FINAL DRAINAGE REPORT
FOR
LOT 5 OF CLEARWAY
EL PASO COUNTY, COLORADO

SEPTEMBER 2022

PCD Project No. PPR-22-034

Nyloplast 24" Standard Grate Inlet Capacity Chart

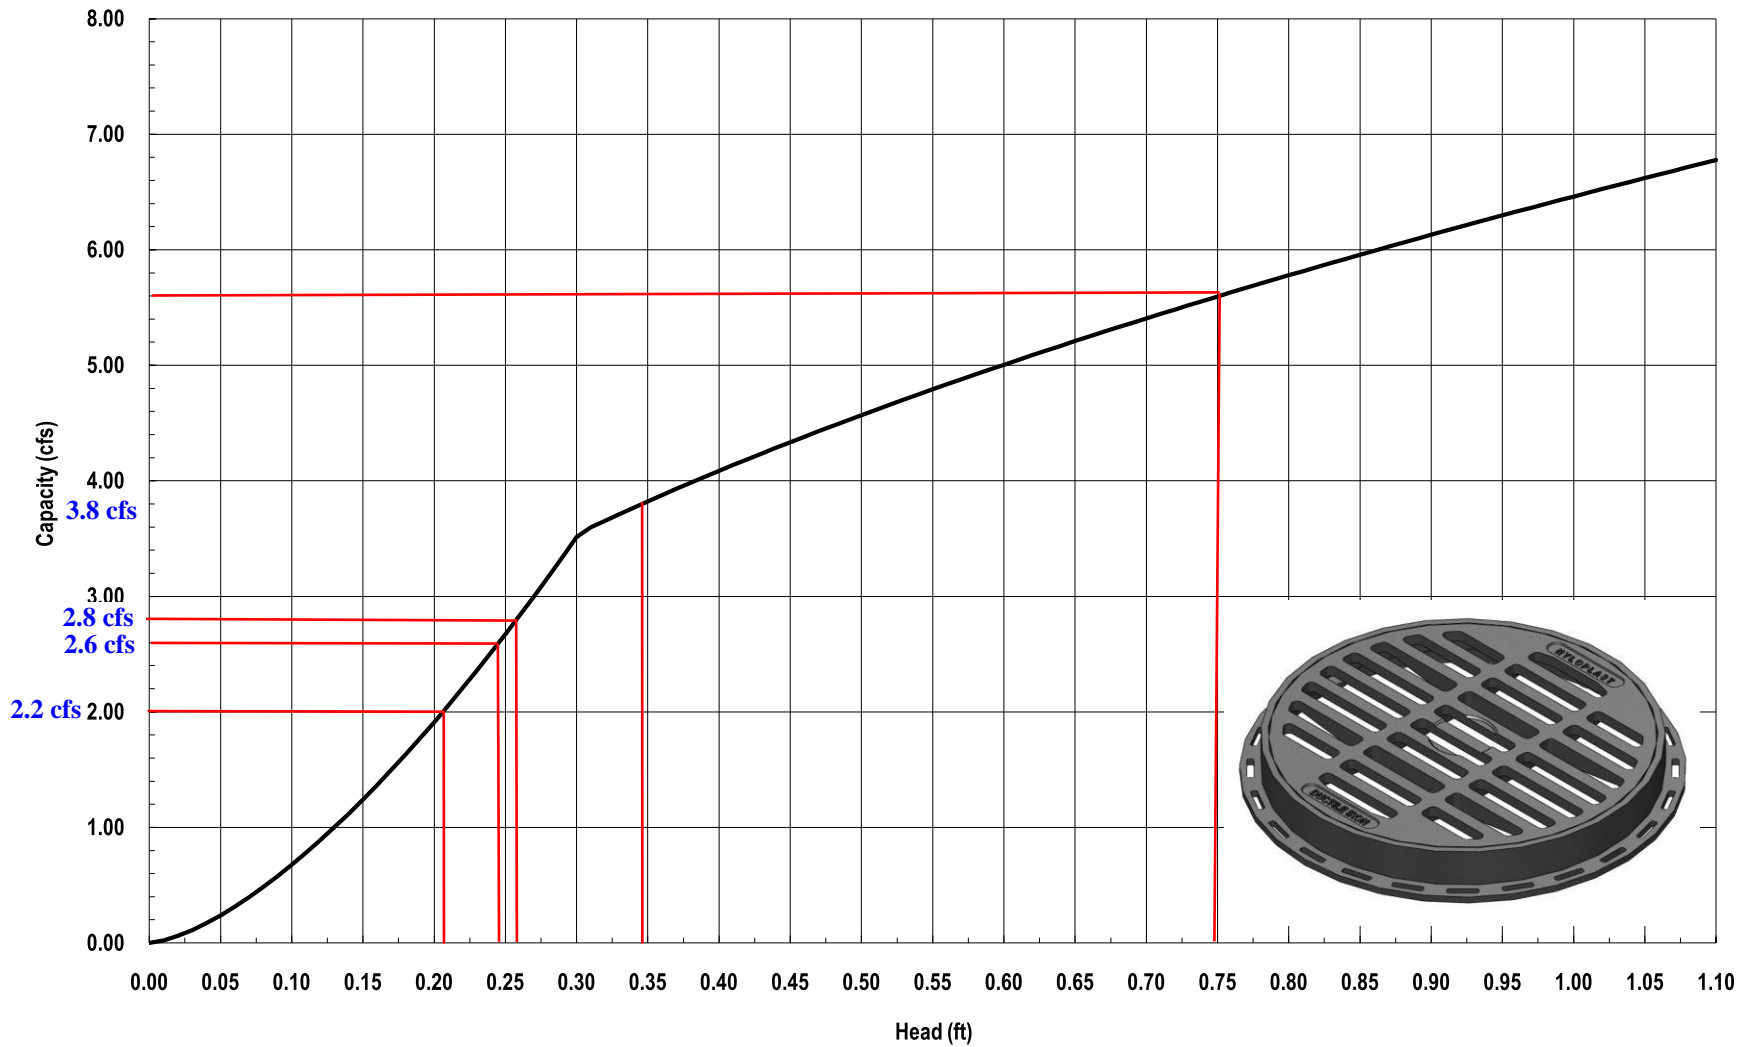
A 24" nyoplast grate inlet is shown on the plans. Please revise accordingly.

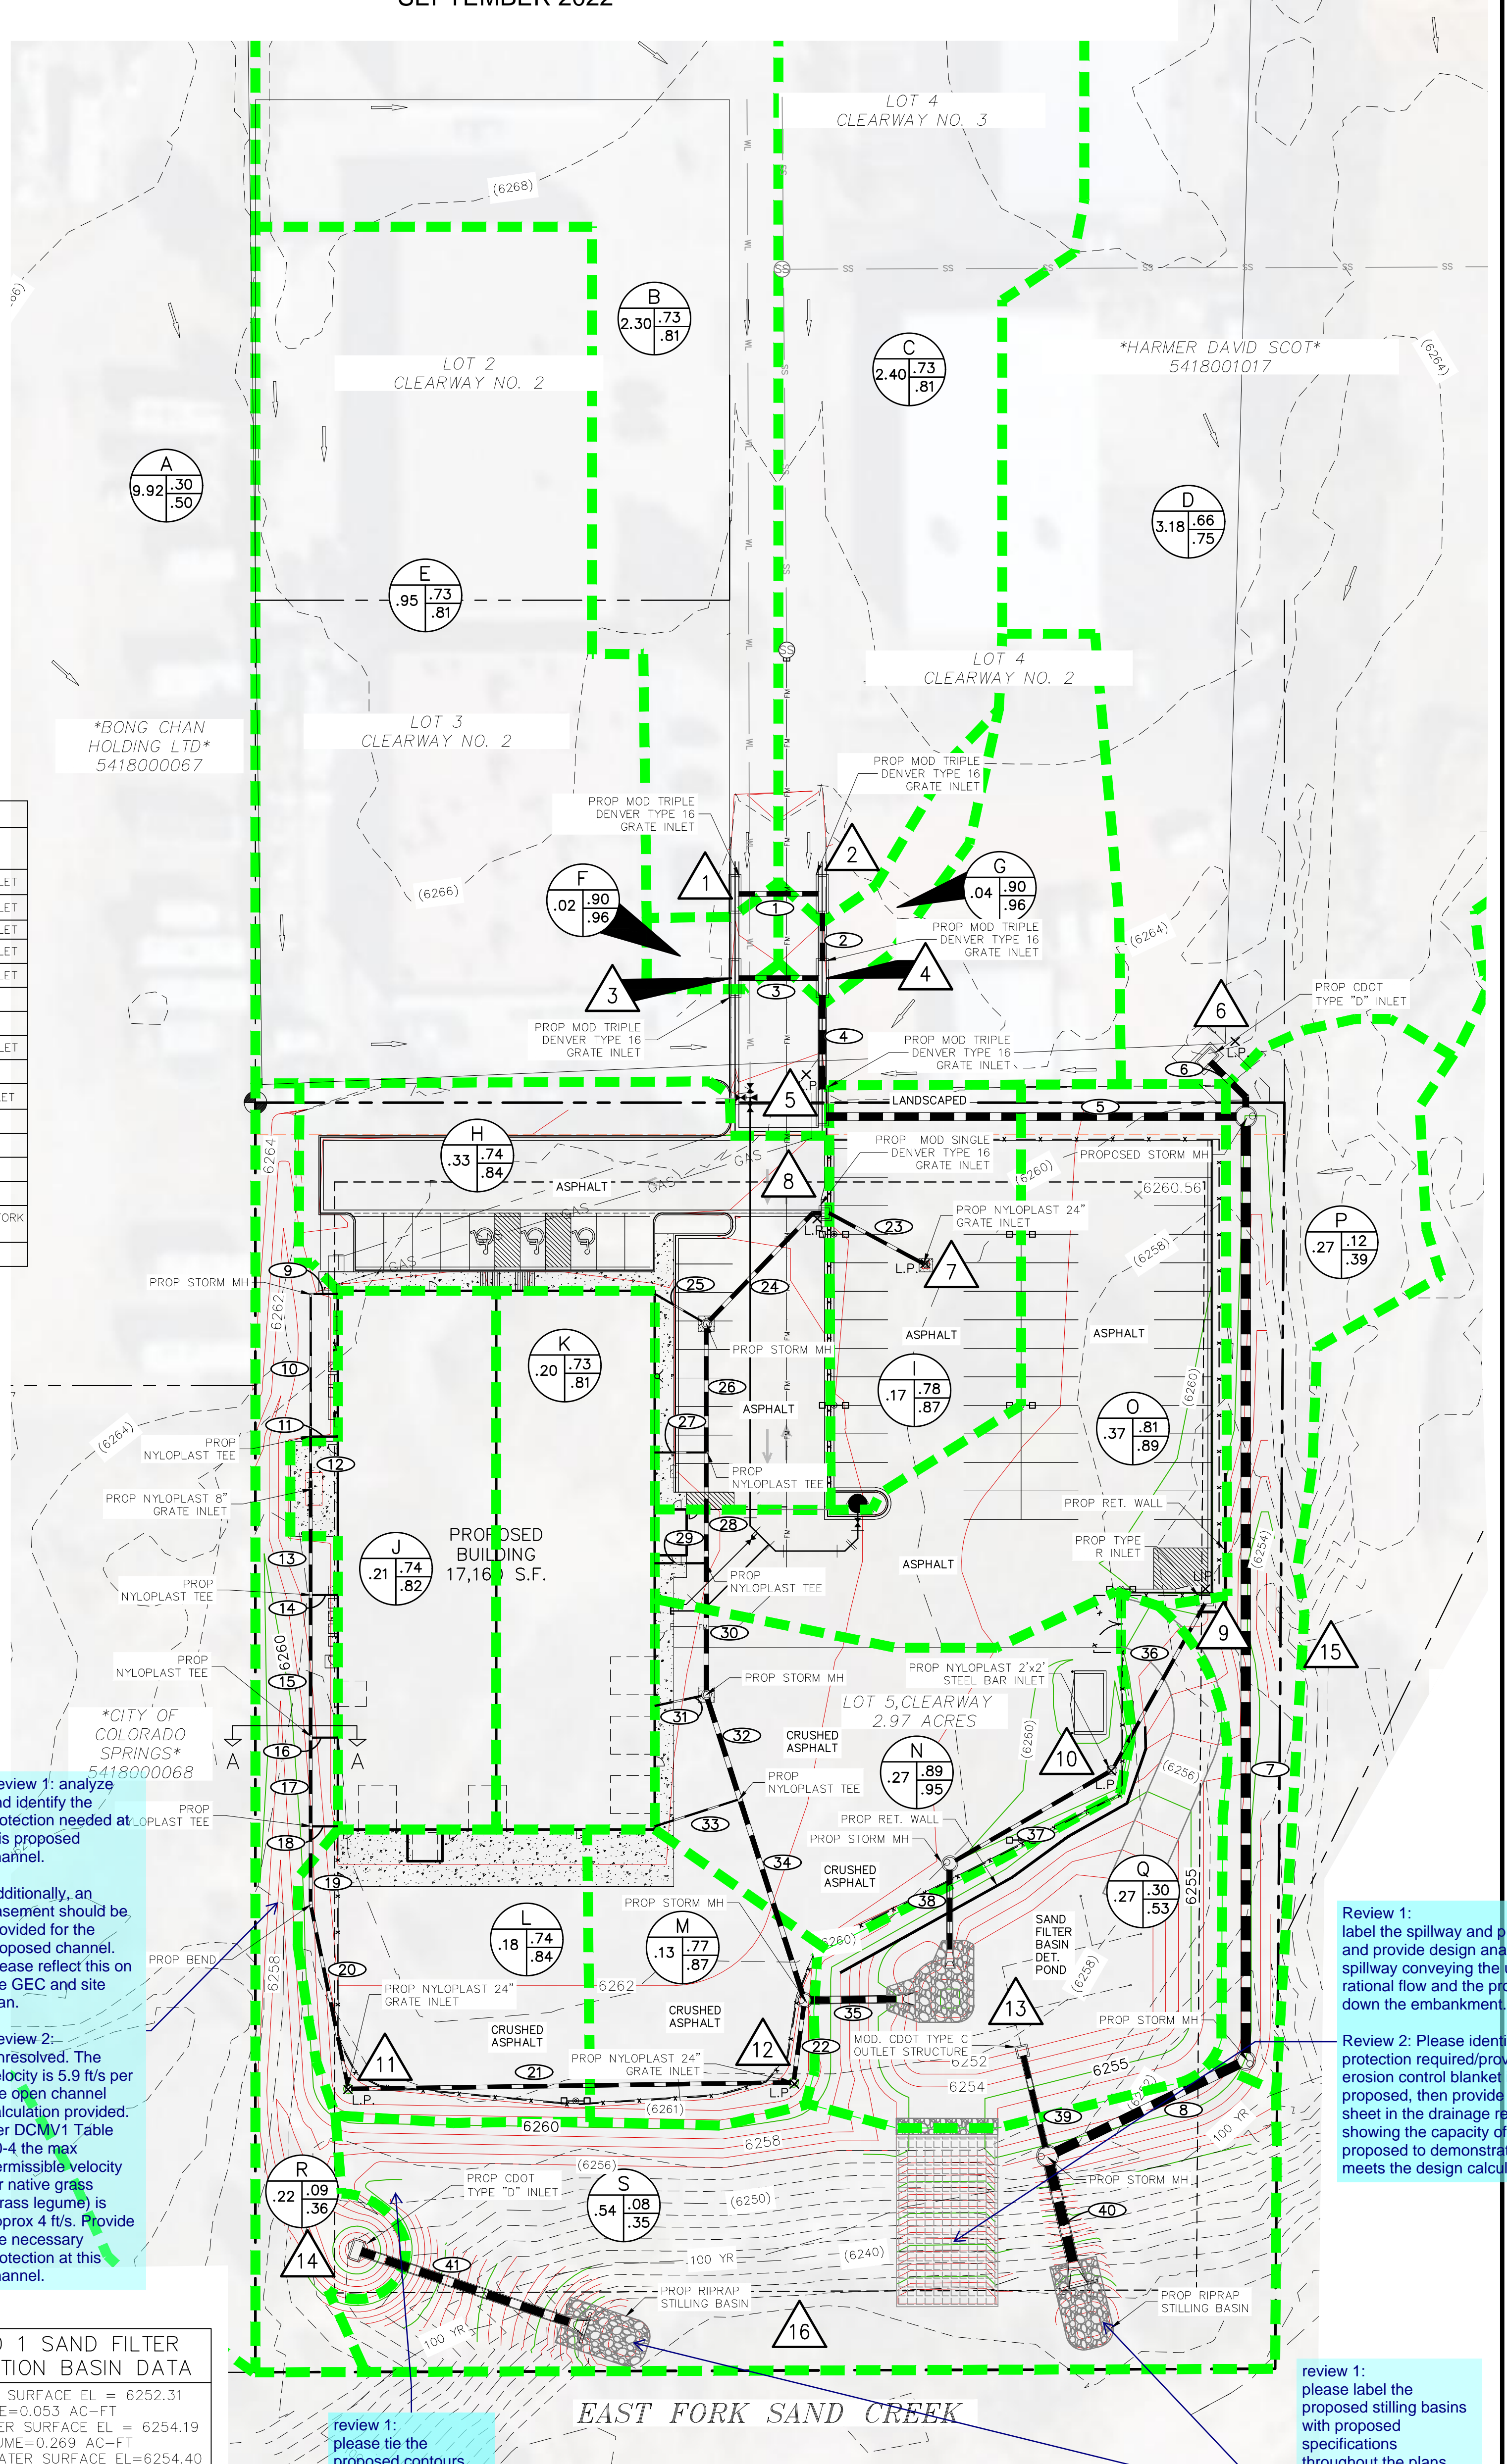
Additionally, an easement should be provided for the proposed channel. Please reflect this on the GEC and site plan.

Review 2: Unresolved. The velocity is 5.9 ft/s per the open channel calculation provided. Per DCMV1 Table 10-4 the max permissible velocity for native grass (grass legume) is approx 4 ft/s. Provide the necessary protection at this channel.

review 1: please tie the proposed contours with existing contours throughout the plan

Review 1: label the spillway and protection and provide design analysis of the spillway conveying the undetained rational flow and the protection down the embankment.

Review 2: Please identify the protection required/provided. If erosion control blanket is proposed, then provide the spec sheet in the drainage report showing the capacity of the ECB proposed to demonstrate that it meets the design calculation.

review 1: please label the proposed stilling basins with proposed specifications throughout the plans and provide design analysis

Review 2: Unresolved. Provide the nomograph/detail used for the design of the stilling basin in the report. Additionally identify the riprap size.
